Product Change Notification

Change Notification #: 112267-00
Change Title: Intel® Core™ i3, i5 & i7 Series Processors & Intel® Pentium® 3550M, 3560M & 3570M Processors & Intel® Celeron® 2950M, 2960M, 2970M, & 2980M Processors, PCN 112267-00, Label, Country of Origin Label Adding China
Date of Publication: June 20, 2013

Key Characteristics of the Change:
 Label

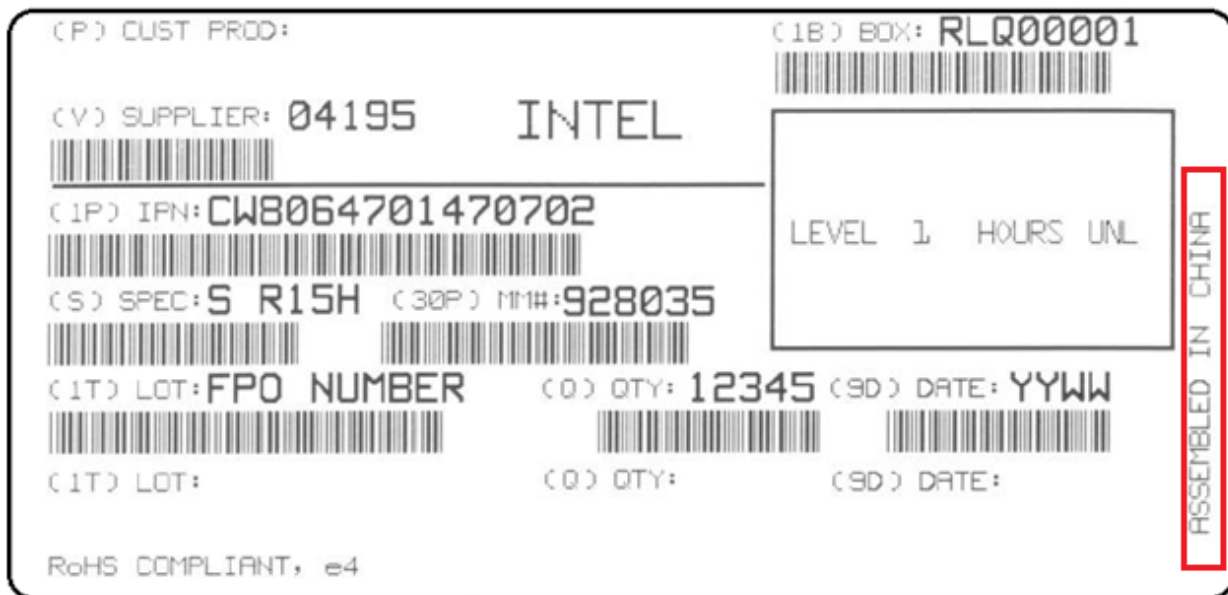
Due to this change, the "ASSEMBLED IN (Country)" on the Intermediate Box Label, see example below, will now include China. All material and equipment will remain the same.
